Planning App Ref:	PL/2026/01506
Service Ref:	Drainage
Date:	09/07/2026

Full planning application for demolition of redundant stone barns; erection of children's nursery with new access, car parking, secure garden and associated landscape and drainage works (Class E); installation of new vehicular access and parking area to retained Southview Farmhouse, erection of replacement rear conservatory, erection of car park, associated erection of boundary treatment, and associated drainage and landscaping.

Southview Farm, Drynham Road, Trowbridge, BA14 0PJ

Refer to the contours shown in the figure below, which illustrate the site topography. (Source: SCALGO).

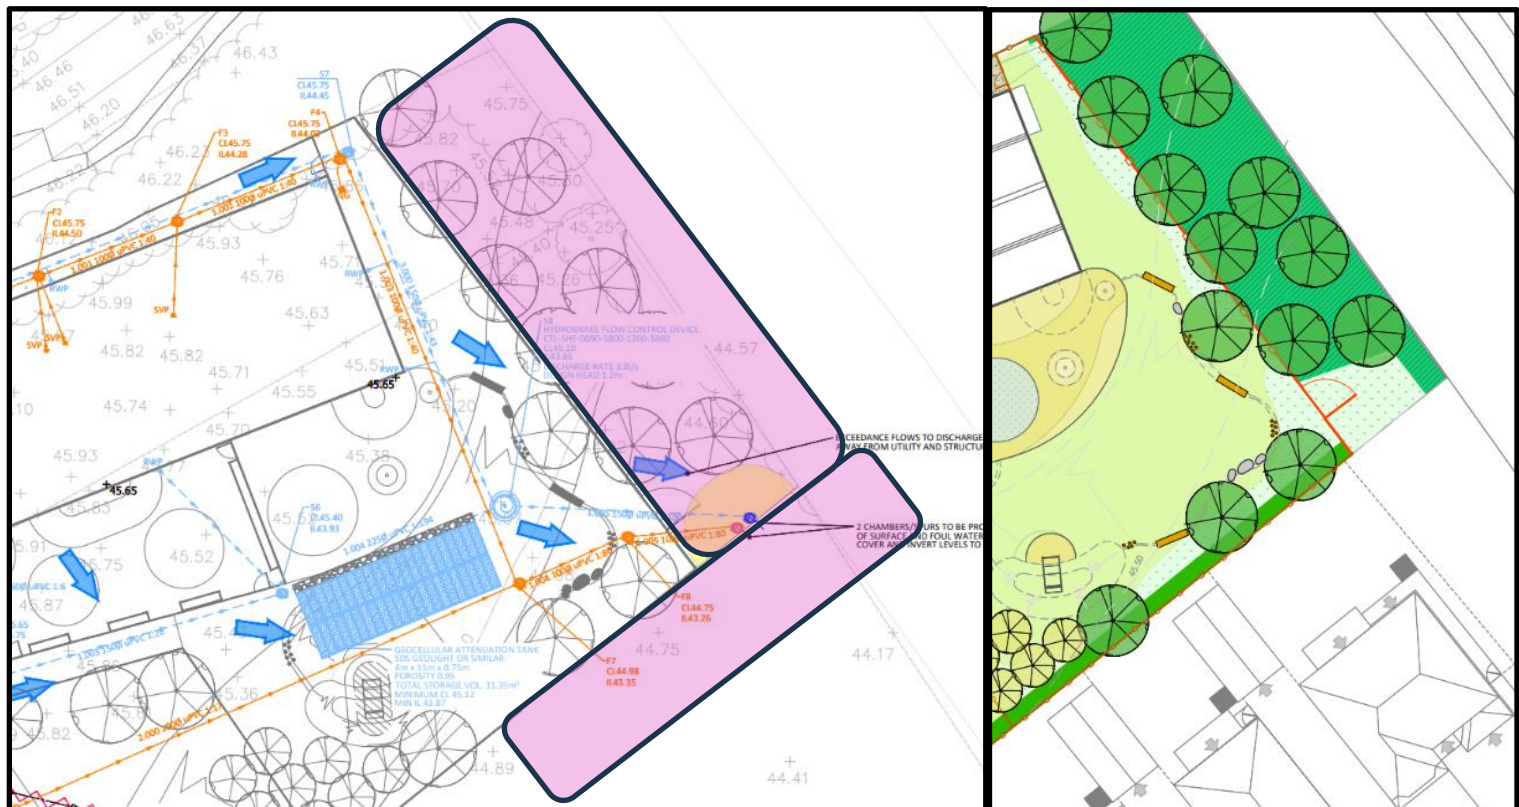
The applicant has provided comments to justify the proposed exceedance strategy; however, it appears that the underlying concern has been misunderstood. While the LLFA acknowledges that ground levels within Areas 1 and 2 are not proposed to change, the increase in impermeable area across the site, together with the need to consider potential drainage system failure scenarios, means that overland flow volumes passing through these areas may increase.

Given that these exceedance flows are currently directed off-site towards neighbouring development and existing infrastructure, the proposed arrangement is not acceptable. The applicant should therefore propose measures to intercept, manage, and contain flows within the site boundary to ensure that no increased flood risk or adverse impact is imposed on adjacent land, property, or infrastructure.

There is uncertainty regarding how overland exceedance flows will be directed towards the culvert, raising concerns that flows may not be effectively conveyed and could increase flood risk to the existing railway track.

1. Post-development exceedance routing plans indicate that surface water exceedance flows are directed towards the future proposed development by Redrow Housing and the existing railway corridor.

The applicant is required to submit further details demonstrating how exceedance flows will be safely managed in the pink areas, demonstrating how exceedance will not increase flood risk to the future Redrow Housing development and the existing railway infrastructure. The LLFA would expect the applicant to manage flows onsite, without directing flows towards existing or proposed development.
